2. 11 Mall Road - Game On & Loretta's Last Call

PLANNING BOARD AGENDA FOR JANUARY 13, 2026 - 7:00 PM

Below please find our responses comments discussed in our December 9, 2025 meeting and at the PB meeting. Below please find each comment followed by our response in **bold**.

Enclosed please find our responses to your letter dated December 19, 2025. Below please find each comment followed by our response in **bold**.

FIRE TRUCK MOVEMENT PLAN

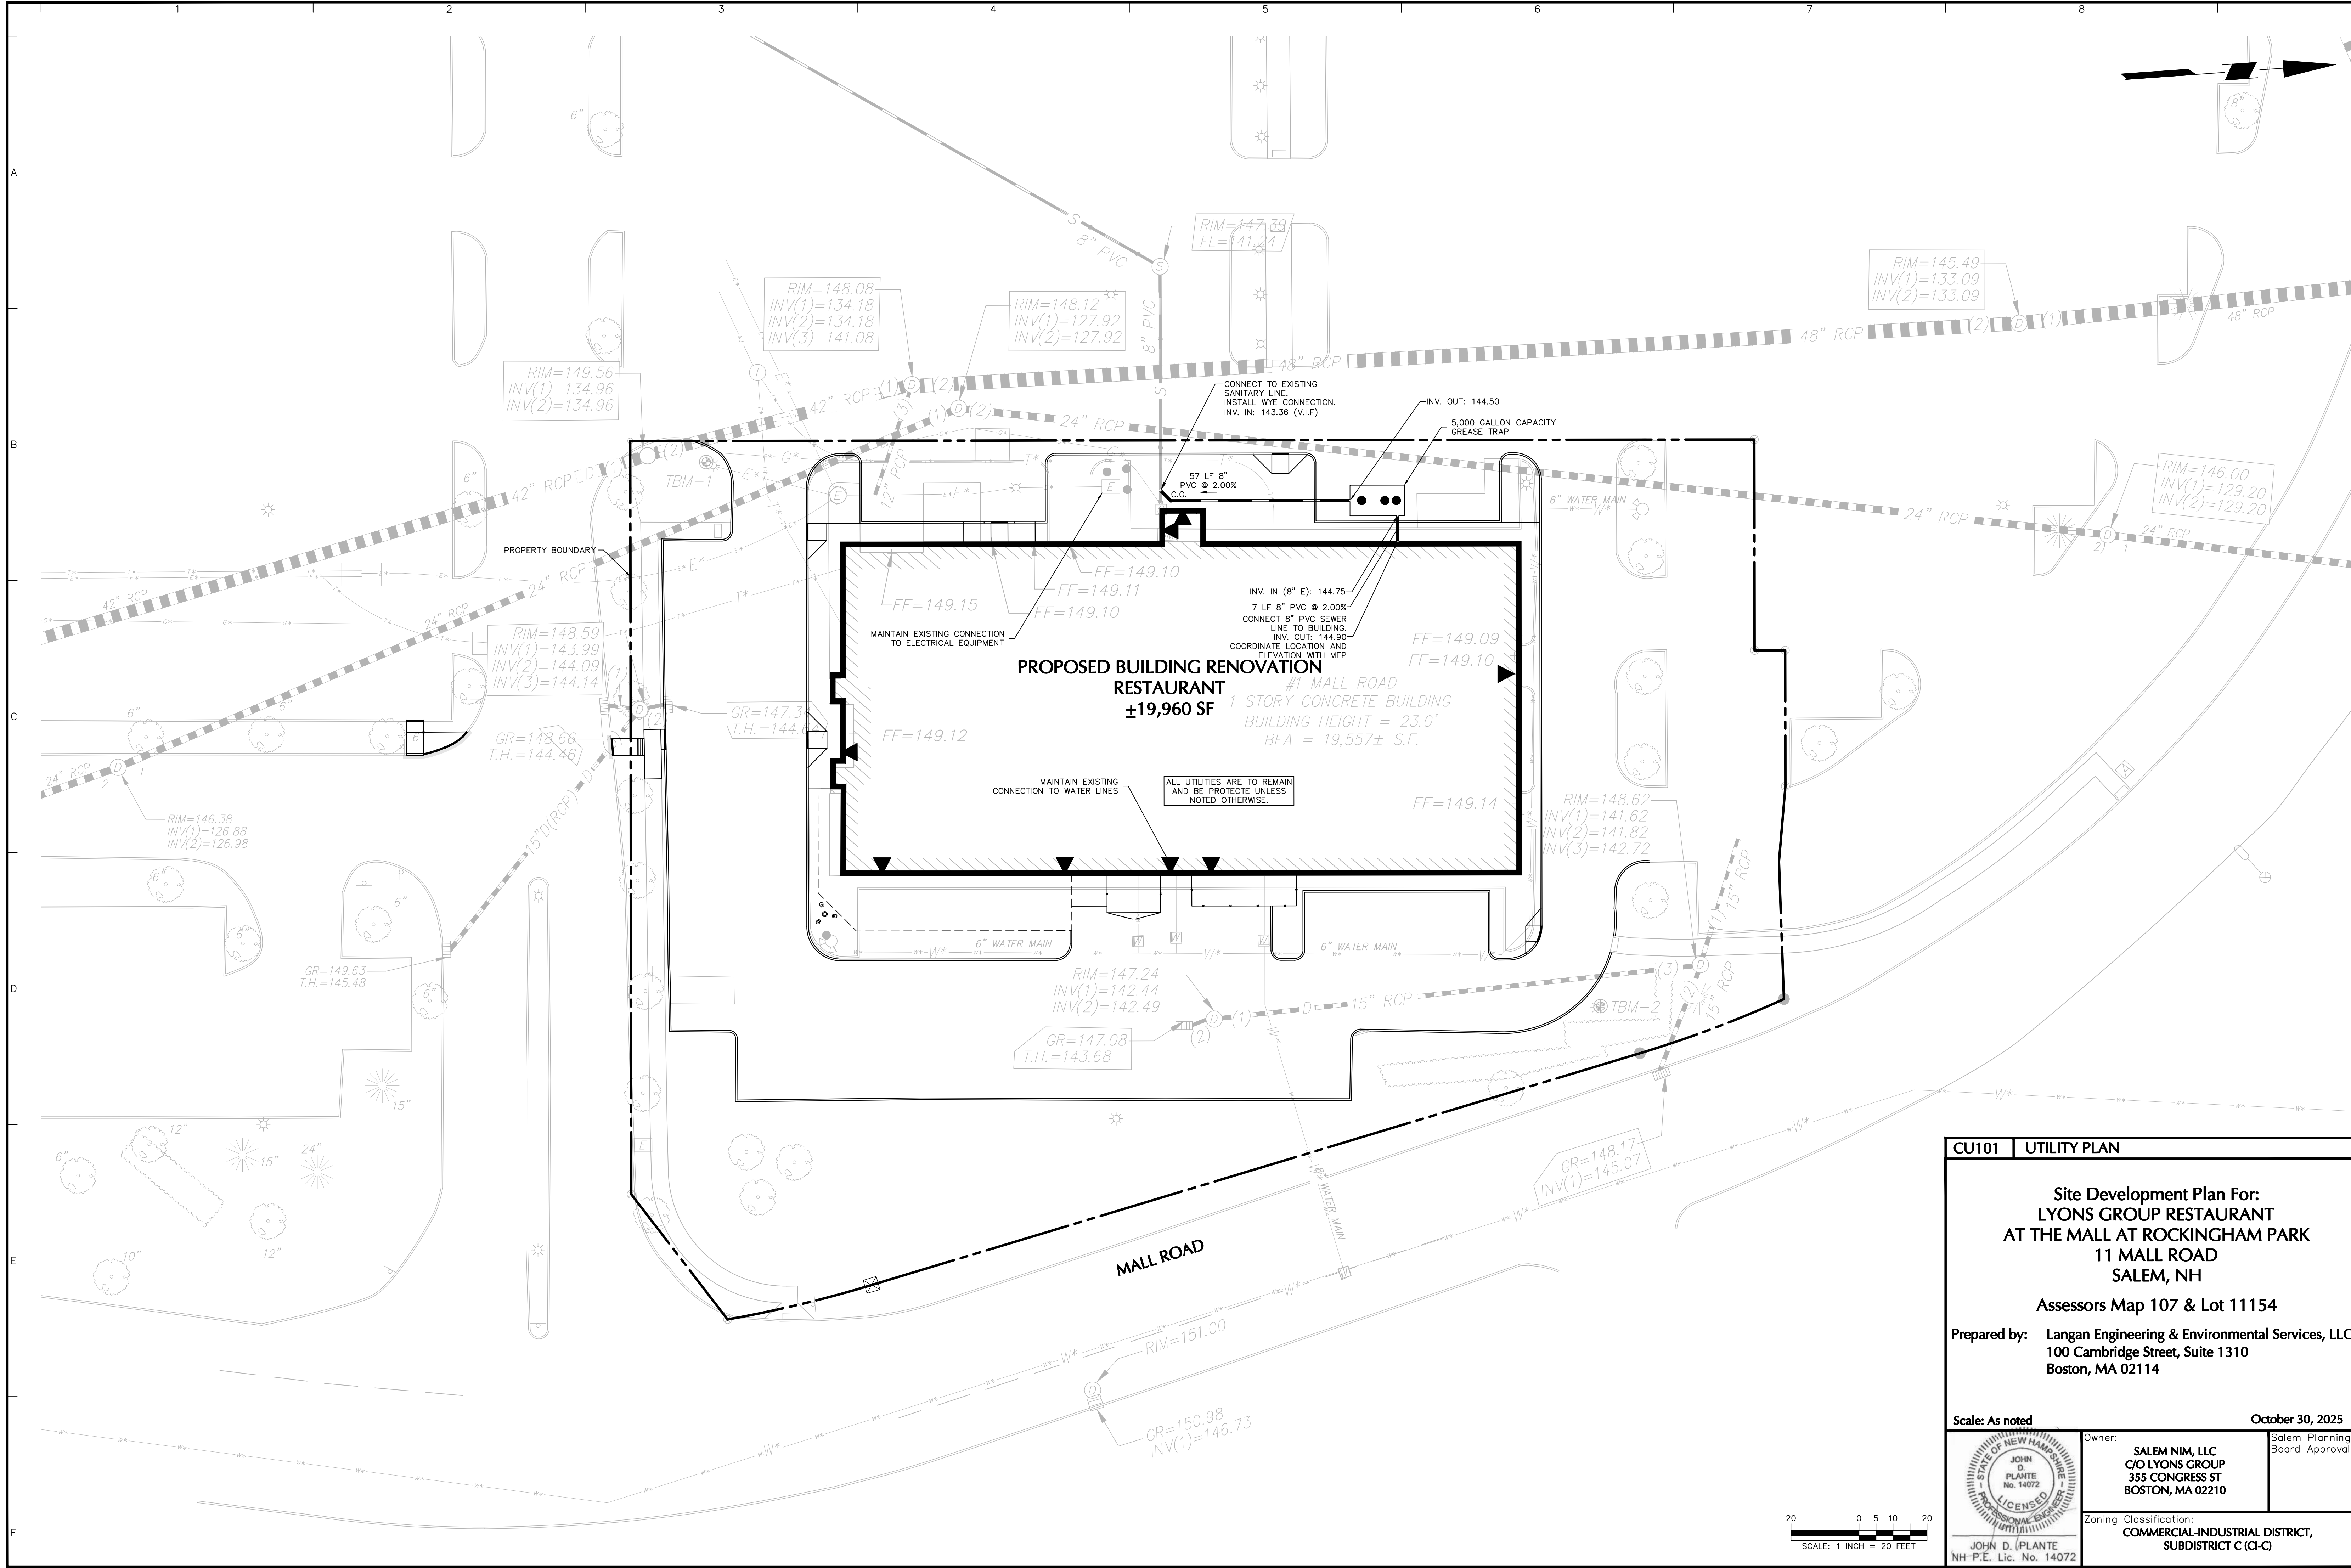
Site Development Plan – A vehicle tracking analysis should be prepared that demonstrates: 1) compatibility with Salem fire apparatus, and 2) how the dumpsters will be serviced. According to Sheet CS101, 68 spaces are proposed within the subject site. It should be noted that the peak parking demand estimates range from 158 to 395 occupied spaces. This means that there is the

COMMENT RESPONSE: *Vehicle turning movement demonstrations are provided on Sheets TM101 and TM102. The 85th percentile (peak) parking estimates for Loretta's and Game On! are 266 spaces, which is 71% of the available parking spaces within Lot C1.*
